# Final Environmental Impact Statement Flambeau Mining Co. — Copper Mine Ladysmith, Wisconsin

March 1990

A Draft EIS (DEIS) was published on September 6, 1989 and circulated for public and government agency review. The comments received on the DEIS were used to develop this Final EIS (FEIS). A summary of public comments, government agency comments, and DNR responses are contained in Chapter Five.

**Figure 1-1**  
Project Location in Rusk County

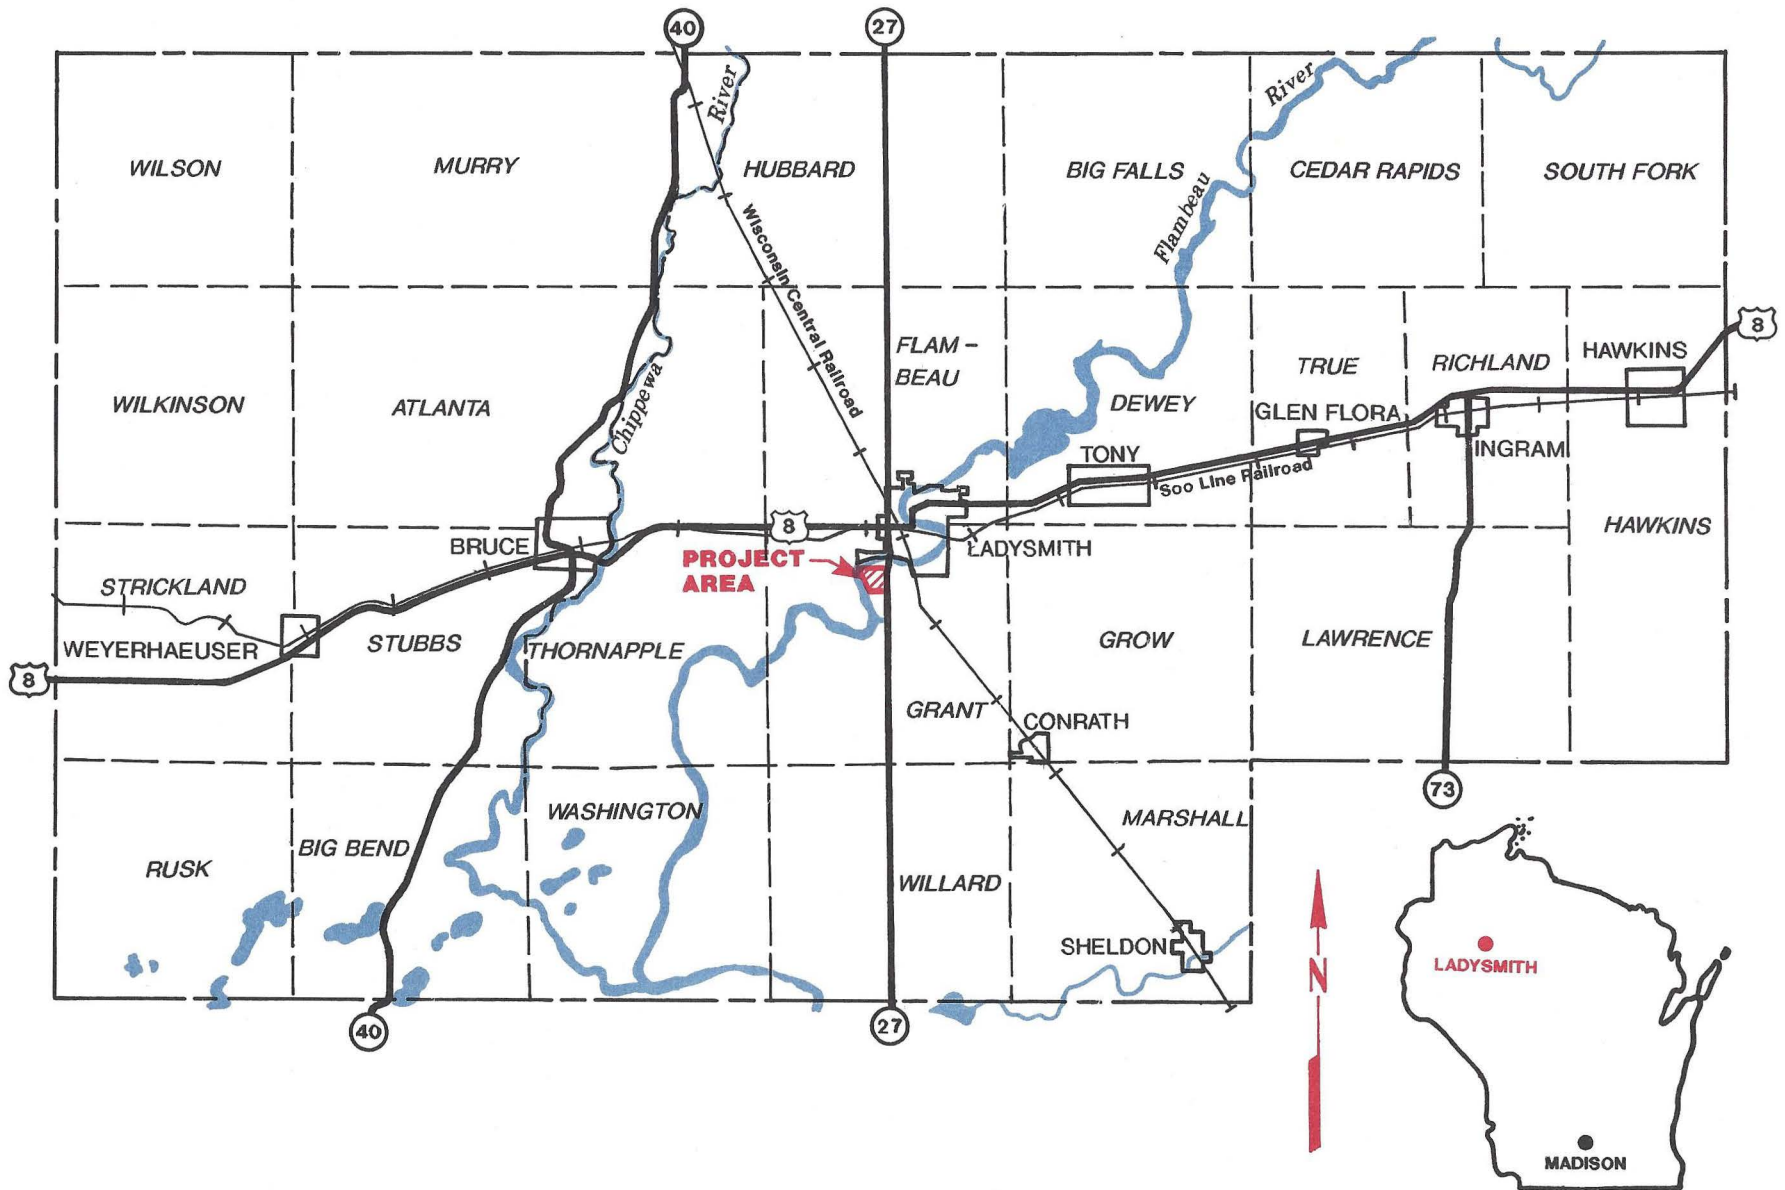
- 33 19. Fig 1-1. Add a scale. [TE]
- 34 20. Fig 1-2. Clearly delineate "project area," "mine site", and the area subject to the proposed mining permit on this illustration. [TE]

**Figure 1-3**  
Proposed Project  
Facilities

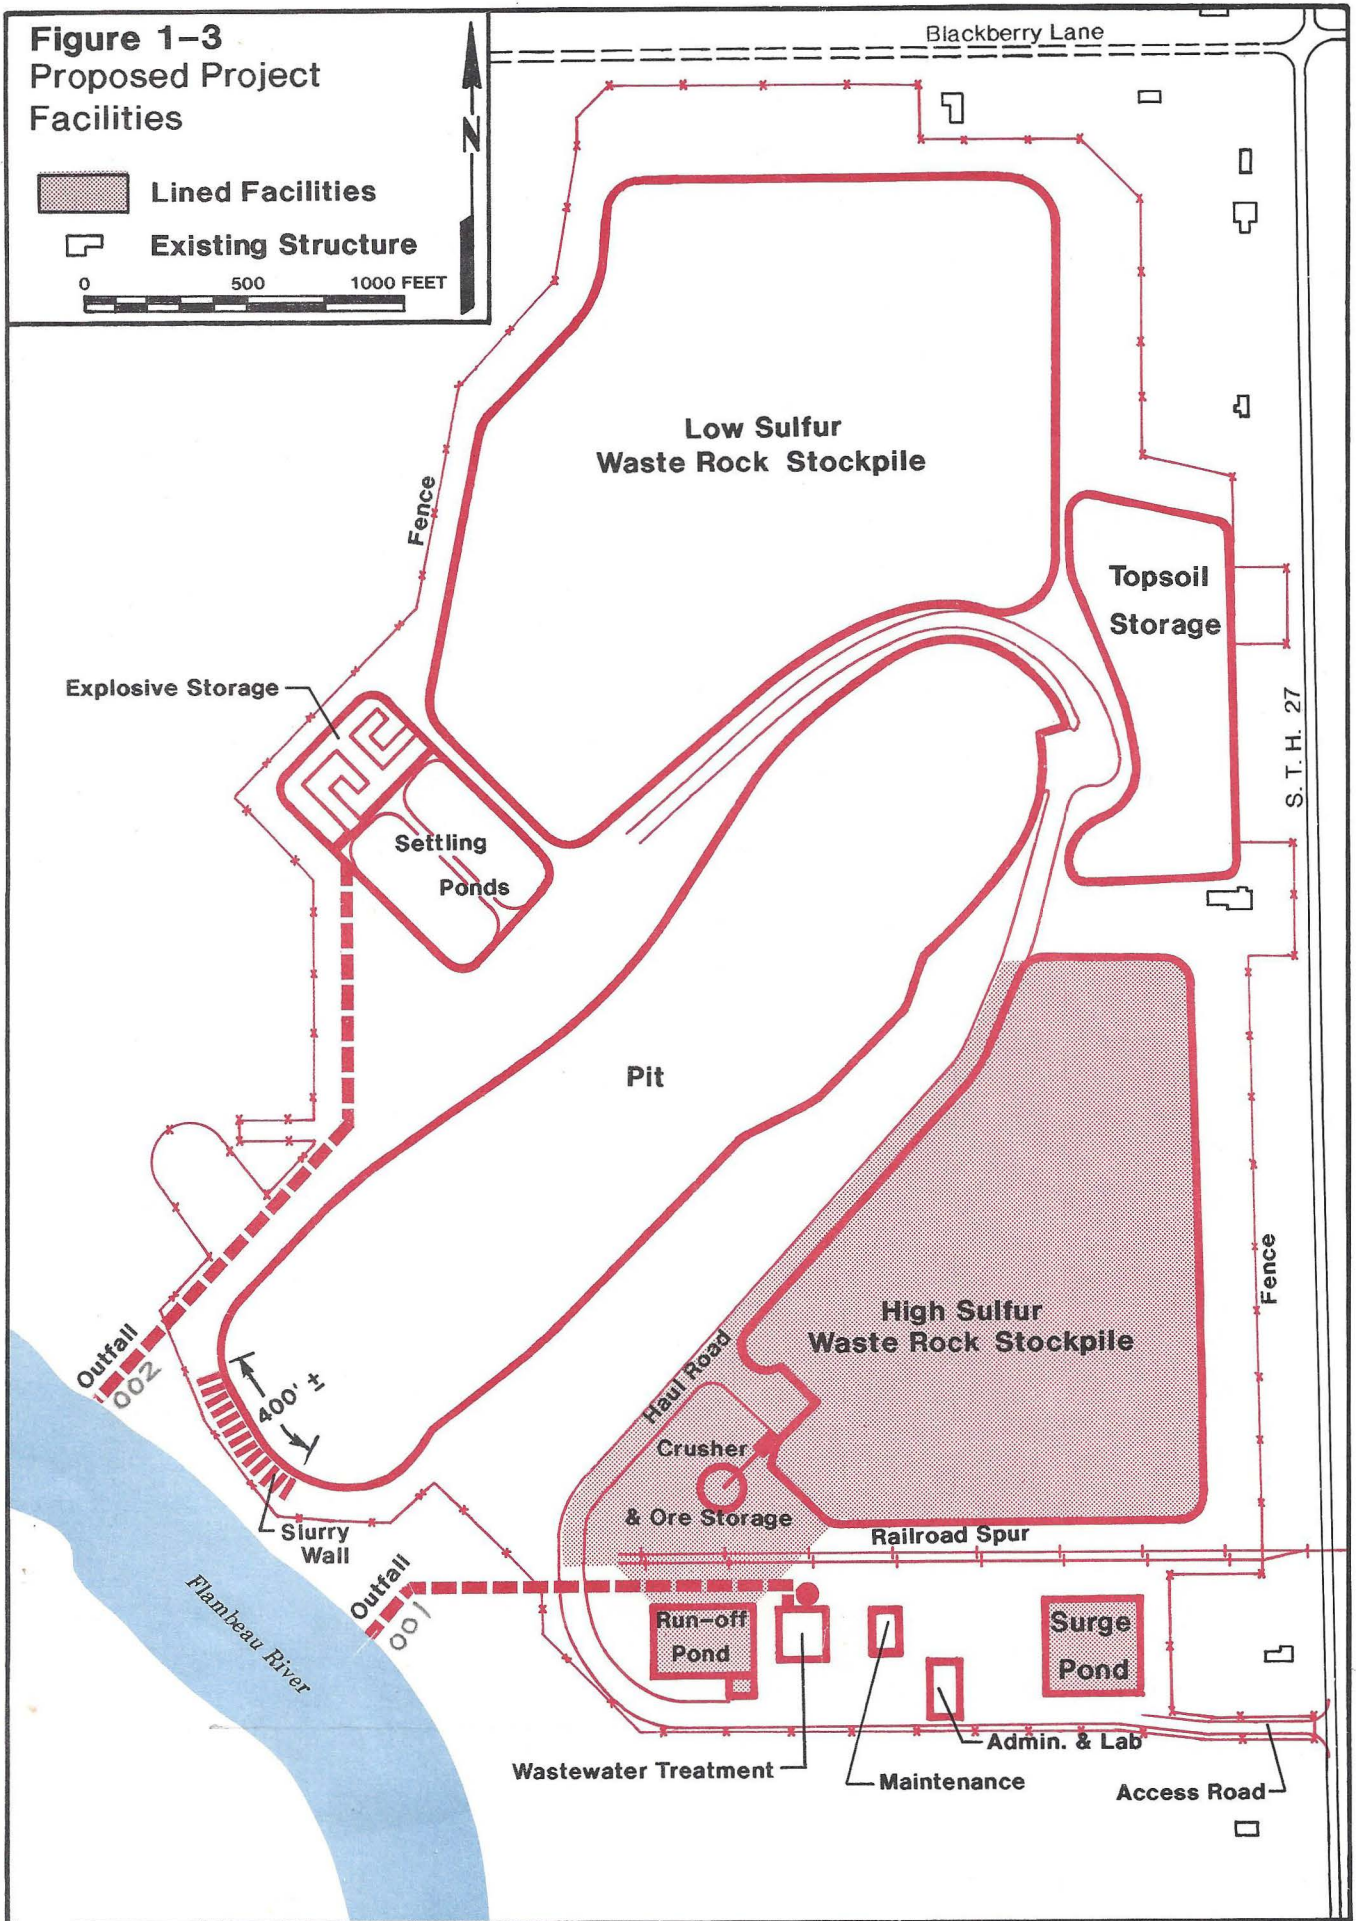
- 35 21. Figure 1-3. Figure shows two small buildings (in black) along east edge of fenced area. Will these buildings remain on site or will they be removed? Explanation of the figure should clarify what those structures are in relation to the Proposed Project Facilities. [TE]

**Figure 1-4** Open Pit Cross Sections

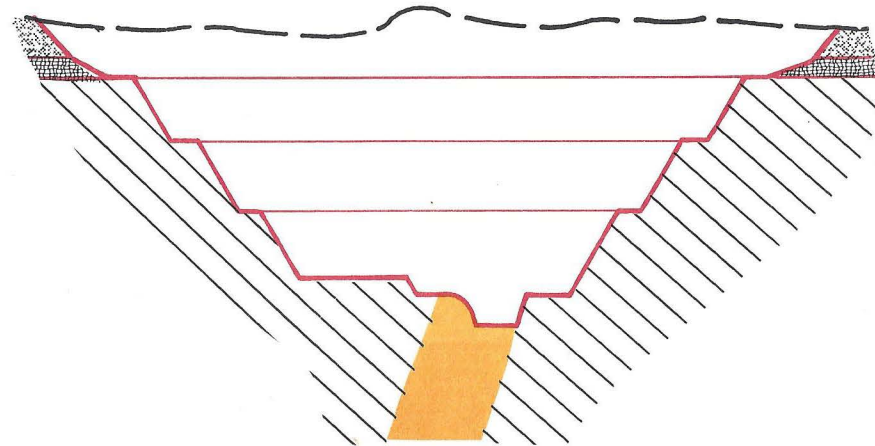
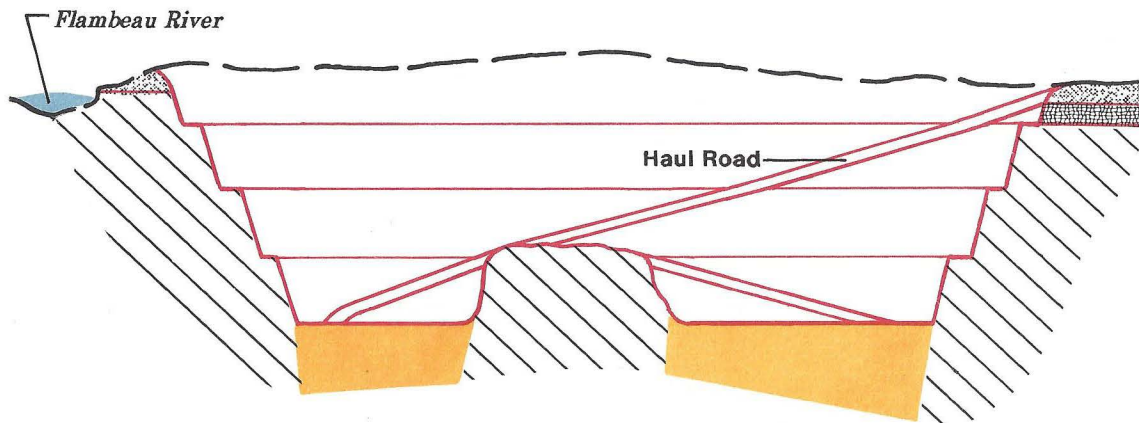
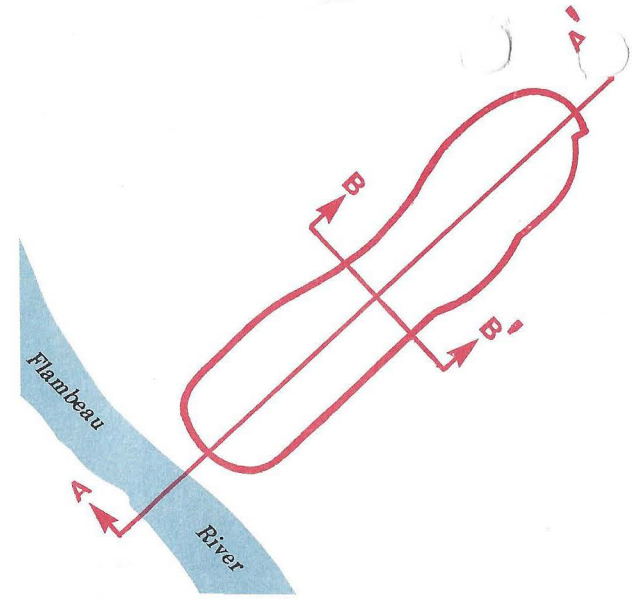
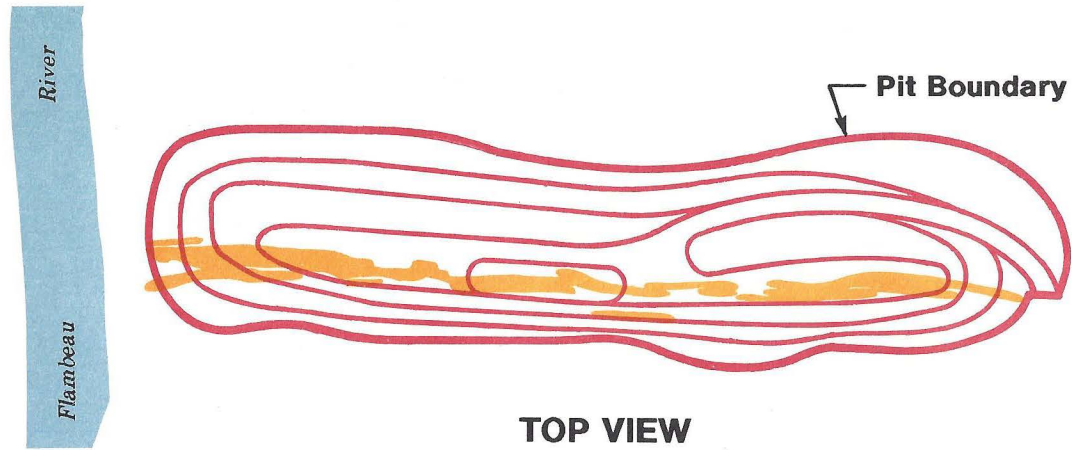
- 36 22. Figure 1-4. Use of term "bedrock" appears to exclude the sandstone, but the Cambrian-age sandstone is part of the area's bedrock. The hachure-symbol unit designated "bedrock" should be redesignated as "Precambrian crystalline rock" or "crystalline rock." See Figure 1-5. [MM,TE]

**Response 36** - Figure 1-4 was modified to address this concern.

**Figure 1-7**  
Low Sulfur Waste Rock  
Stockpile Cross Section  
(Not to Scale)

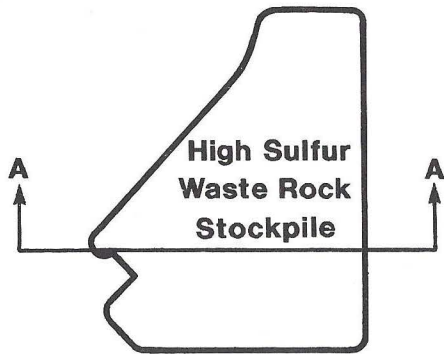
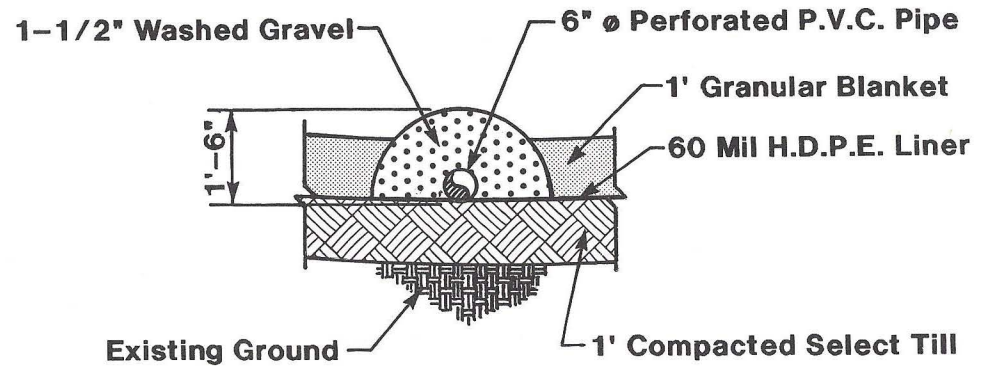
- 40 26. Figure 1-7. The Location Map should include a scale. Section A-A, however, should state that no scale is implied; that is, that is a schematic cross-section. [TE]

**Figure 1-8**  
High Sulfur Waste Rock  
Stockpile Cross Section  
(Not to Scale)

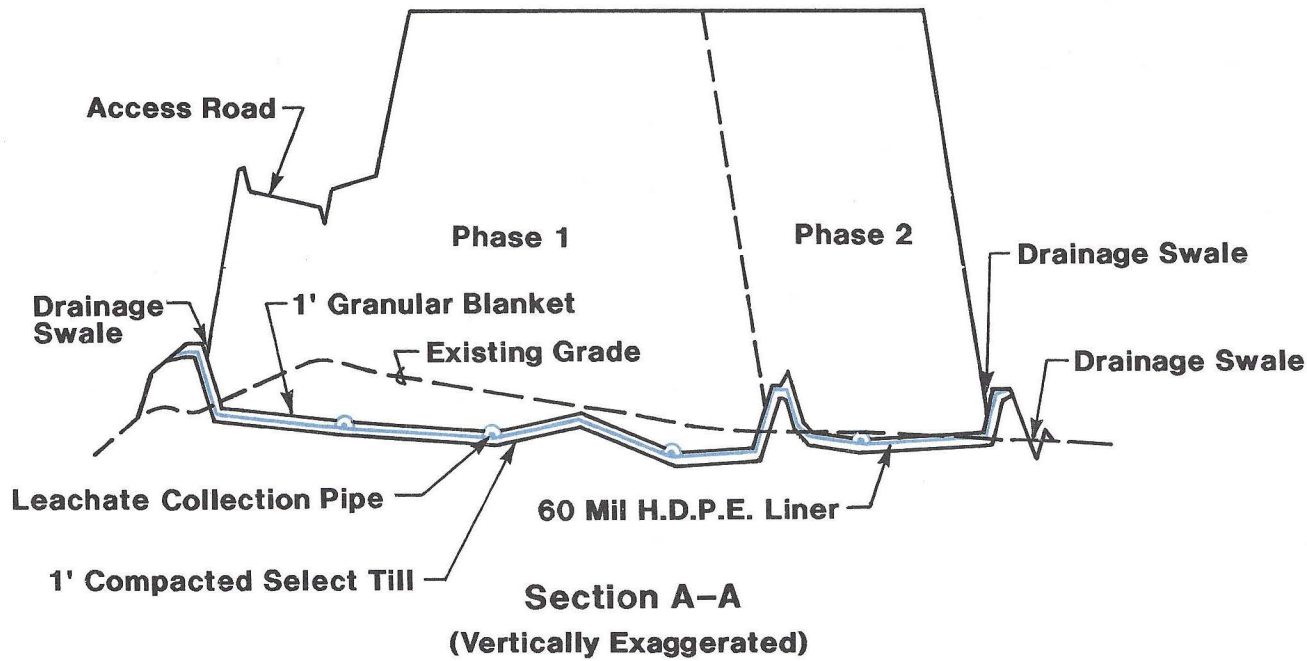
- 44 30. Figure 1-8. A scale should be added to both the Plan View and the cross-section view. [TE]
- 45 31. Page 12, paragraph 8. The term "lime slaking" should be included in the glossary. [MM]

**Distribution of Middle Precambrian Metavolcanic Rocks in Northern Wisconsin**

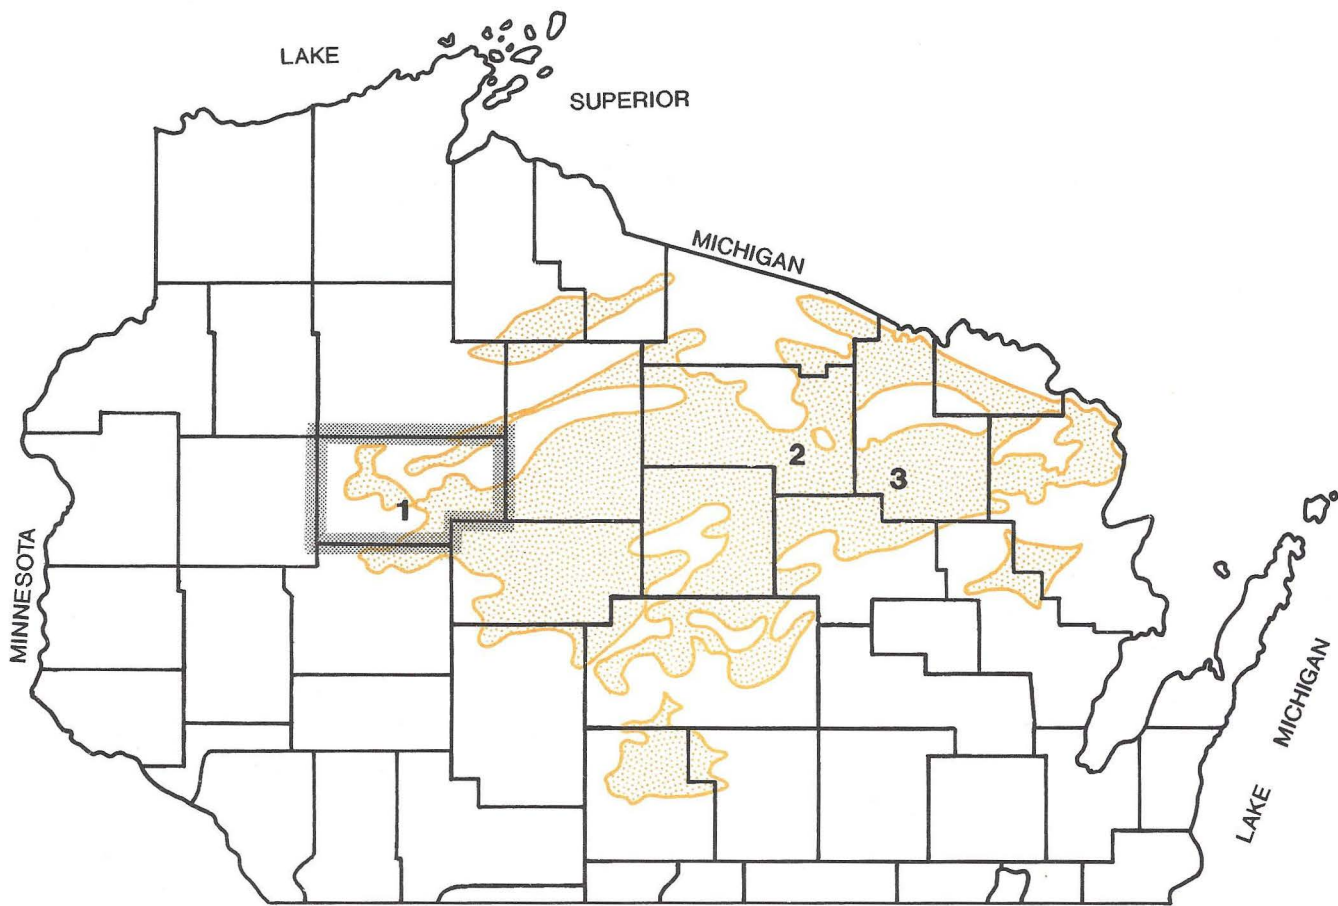
- 63 49. Page 23, paragraph 7. Suggest deleting "containing" from the phrase "asbestos containing minerals" for clarity. [MM]
- 64 50. Figure 2-1. This figure represents an interpretation of the distribution of "Middle Pre-Cambrian [sic] Metavolcanic Rock" that is not correct based upon over 10 years of additional work since this figure was first published. A more current depiction of the distribution of these rocks is readily available in the geologic literature. [MM]
